Product / Process Change Notification (PCN)

PCN #: PCN_IndLQS_2_20240520 Affected Series: WE-LQS-Series; 74404032xxxx, 74404031xxxA PCN Date: February 20, 2024 Effective Date: May 20, 2024	Change Category: <input type="checkbox"/> Equipment / Location <input checked="" type="checkbox"/> General Data <input type="checkbox"/> Material <input type="checkbox"/> Process <input type="checkbox"/> Product Design <input type="checkbox"/> Shipping / Packaging <input type="checkbox"/> Supplier <input type="checkbox"/> Software
Contact: Product Management Phone: +49 (0) 7942 - 945 5001 Fax: +49 (0) 7942 - 945 5179 E-Mail: pcn.eisos@we-online.com	Data Sheet Change: <input checked="" type="checkbox"/> Yes <input type="checkbox"/> No Attachment: <input type="checkbox"/> Yes <input checked="" type="checkbox"/> No

Description and purpose of change:
 Because of a database mismatch, Würth Elektronik will update the datasheet of WE-LQS 74404032xxxx and 74404031xxxA.

CAD drawing before the datasheet correction	CAD drawing after the datasheet correction

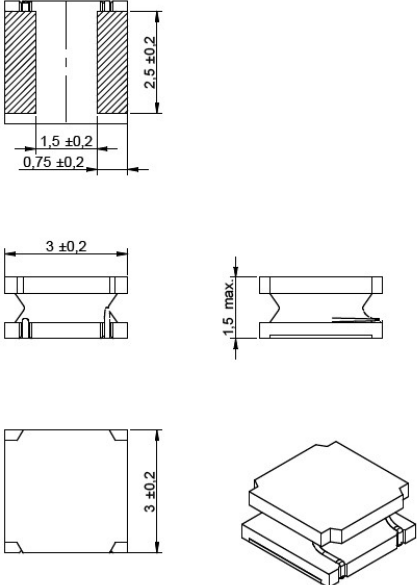
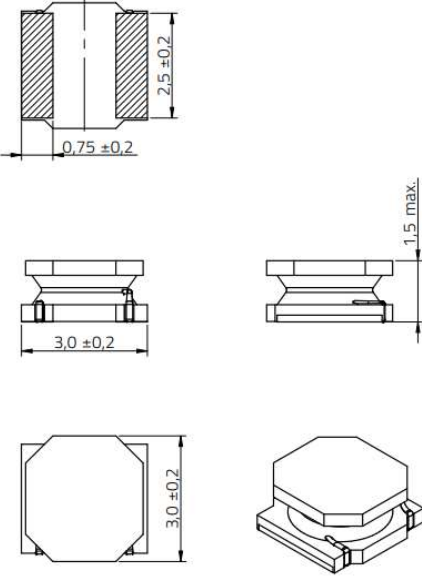
A wrong CAD article drawing will be replaced by a corrected one.
 The recommended Land Pattern stays the same.
